Re: Morrison Supply 301 Indiana SE_{cc}
Request for Permanent C.O. – Acceptable
Engineer's Stamp dated: 08-08-13 (K-18/D021)
Certification dated: 4-30-14

**Re: Morrison Supply
Request for Permanent C.O. – Not acceptable
Engineer's Stamp dated: 08-08-13 (K-18/D021)
Certification dated: 12-12-13**

RE: **Morrison Supply – Warehouse, 301 Indiana SE**
Grading & Drainage Plan for Building Permit
Tract 6-A-1, Block 14, Fairgrounds Addition

File **K18-D021**
PE Stamp: 6/21/13

Drainage Plan

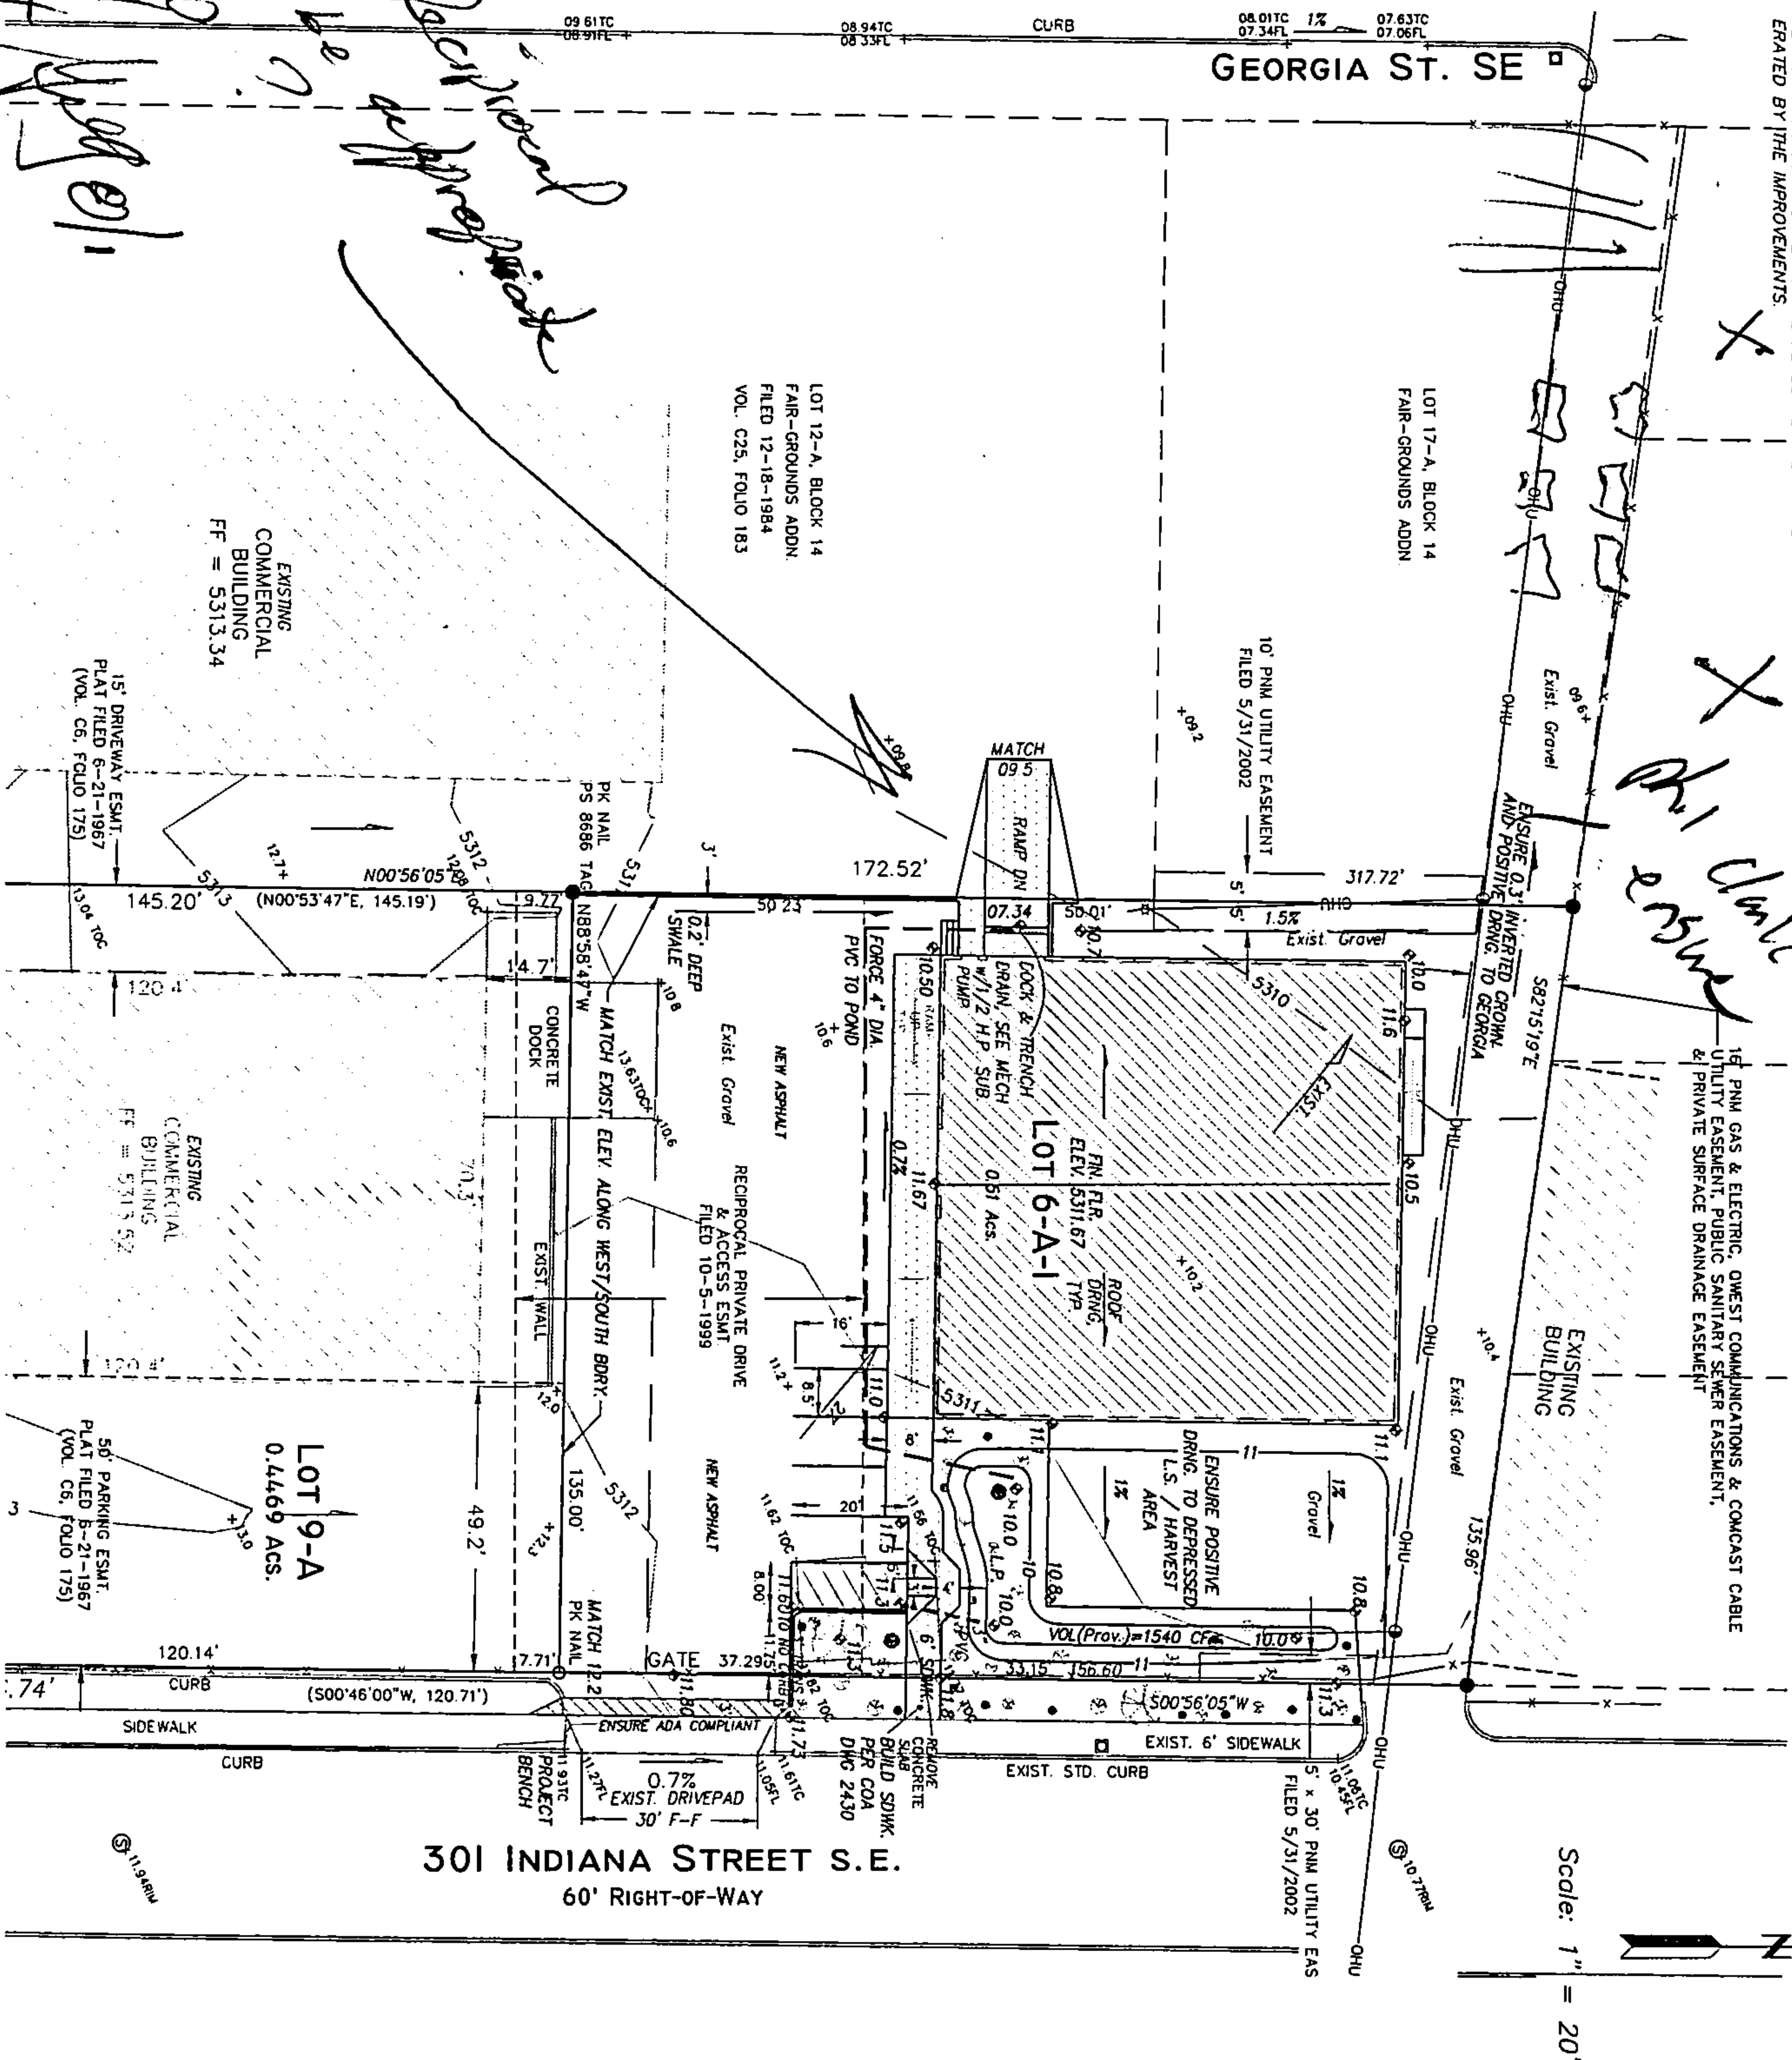
1. This plan shows a loading bay ramp, west of the building, which acts as a sump for runoff from the southern 25% of the site paving. Provide pump calculations to show that flows intercepted at this point are conveyed to the harvesting pond, as shown, and are not allowed to overflow to Tract 12A at elev. 9.50.

- a. Is the 8" force main intended to run under the building pad? The Referenced Mech. Plan was not provided with this submittal.
 - b. Provide detail of Pump inlet at sump, and pipe discharge to pond. *20eller 268*

- c. Provide documentation of the Construction and Access Easements necessary to support the ramp construction and operation on Tract 12A.
2. What is the double line along the south portion of the west lot line (wall or curb)?

3. Clarify the point and direction of overflow from the water harvesting pond, on the east edge of the site. Will flows exist through the old alley entrance, northeasterly to Indiana Street, or will they drain westerly in the vacated alley corridor?

4. This plan has a note to "ENSURE 0.3' INVERTED CROWN AND POSITIVE DRNG, TO GEORGIA" in the Private Surface Drainage Easement (Vacated Alley) along the north edge of Lot 17-A. Provide survey to verify this, or contours and spot elevation for grading.

- a. Is the 8" force main intended to run under the building pad?no - see prior e-mail The Referenced Mech. Plan was not provided with this submittal. See spec sheet, perf curves etc. and new pdf (in e-mail)

- b. Provide detail of Pump inlet at sump, and pipe discharge to pond. See/shown on Arch. and mech.
 - c. Provide documentation of the Construction and Access Easements necessary to support the ramp construction and operation on Tract 12A. The owner, Phil Ingram owns both properties under Kipco.

2. What is the double line along the south portion of the west lot line (wall or curb)? Edge of asphalt and the bdry. It is leadered.
3. Clarify the point and direction of overflow from the water harvesting pond, on the east edge of the site. Will flows exist through the old alley

4. This plan has a note to "ENSURE 0.3' INVERTED CROWN AND POSITIVE DRNG, TO GEORGIA" in the Private Surface Drainage Easement (Vacated Alley) along the north edge of Lot 17-A. Provide survey to verify this, or contours and spot elevation for grading. The current plan grades indicate positive drainage to west. The site generally outfalls to the west again, historically.
